CITY OF KELOWNA

MEMORANDUM

File No.: Z04-0003
(3360-20)

Purpose: To rezone from the A1-Agriculture 1 zone to the RU1h-Large Lot Housing (Hillside) zone in order to facilitate a 43 lot single detached housing subdivision

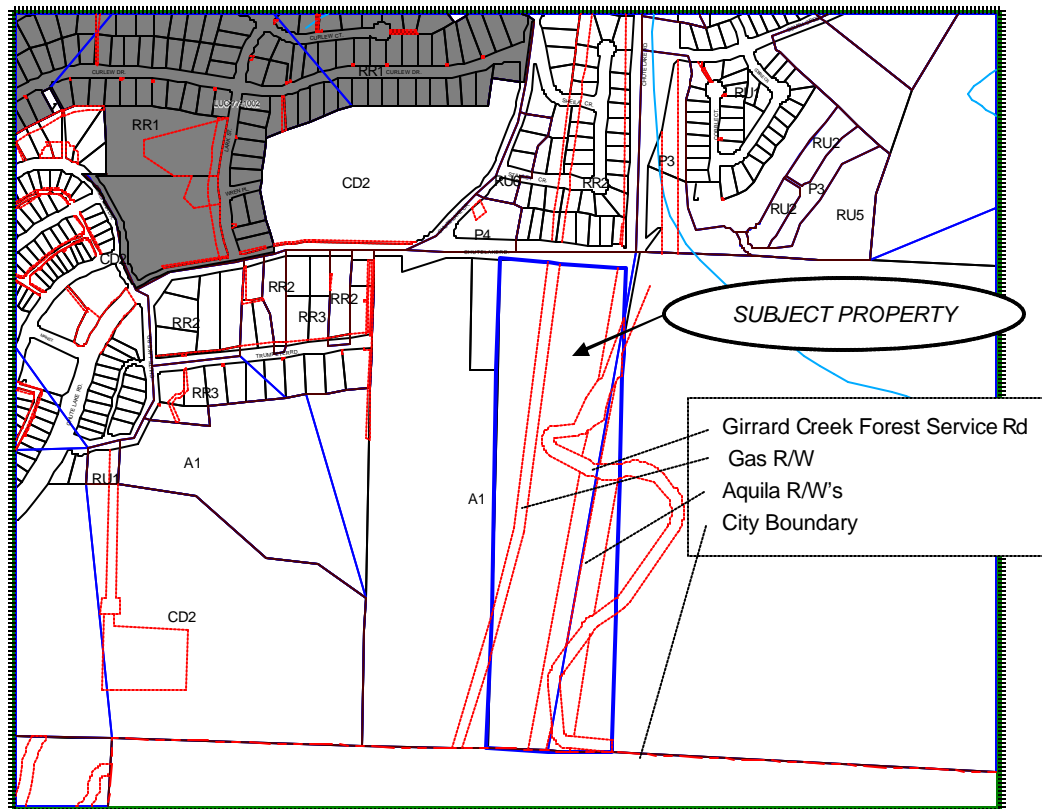
The property is located off the south side of Chute Lake Road, west of the Gillard Creek Forest Service Road. In addition to the forest service road running south through the property, there is a gas right of way and dual Aquila transmission line right-of-ways running north-south through the property as shown on the above map.

- a) An acceptable road preplan for the adjoining lands is required to confirm the alignments and intersections of the Forestry Road extension and Road B.

- b) The upper portion of the property above the 520m contour elevation does not have water service at this time. Therefore, this portion of the property should not be considered part of the zone amendment application unless water system upgrades are proposed and there is an amendment to the OCP.

- c) The maximum contour elevation for water service is 520m, based on the elevation of the Adams reservoir. The upper portion of this property above this contour elevation is not serviceable at this time unless further system facilities are built. Some lots in the lower portion may be affected by this elevation; therefore on the Lot Grading Plan identify the maximum service contour for water and specify the maximum floor elevation that can be built to satisfy Bylaw requirements.

- d) A Collector Road is required in approximately the same location as the existing Forestry Service Road on the East side of the property. This road is required as part of this subdivision as it fronts the development. The Transportation Section indicated that the road section may eliminate parking and allow for two 3.5m vehicle lanes and 1.5m bike lanes (for a road width of 10m) within an 18m dedication. Urbanization (curb & gutter, separate sidewalk and street lighting etc) is required fronting the development. Where other lands front the road it may remain as a rural cross-section. The alignment of this road needs to be finalized and approval obtained from the Ministry of Forests.

- e) Road A and Road C are designated Hillside urban local roads. Dedicate and construct the road in accordance with City alternate standard Drawing TYP-01 (14.0m dedication, 9.0m (boc) road).

At this time it will be designated as an urban Minor Hillside Collector Road in accordance with City alternate standard Drawing TYP-04 with parking/access on both sides (15.50m dedication, 11.0m (boc) road). The cul-de-sac end should make provision for extension in the future i.e. the curb should be squared off fronting lot 33.

The existing hydro corridor is frequently used by the public for access between Chute Lake Road and the South Slopes and Gillard Area. It was also the main route of access during the fire for emergency crews. Parks wants to protect this public access route by establishing a public access ROW agreement over the parcel similar to the route of access (walkway) under the hydro corridor in Neighbour 2 around the Southridge subdivision. The proposed subdivision property lines would need to be adjusted from Lot 18 south to Lot 25 to prevent privatization of the corridor.

The basic lot layout concept as it impacts the Terasen Gas right-of-way is acceptable to Terasen Gas except for Lots 12 & 13 where the lot boundary should be re-adjusted so as not to be in the centre of the right-of-way where the pipeline is located. Detailed comments available through the subdivision application.
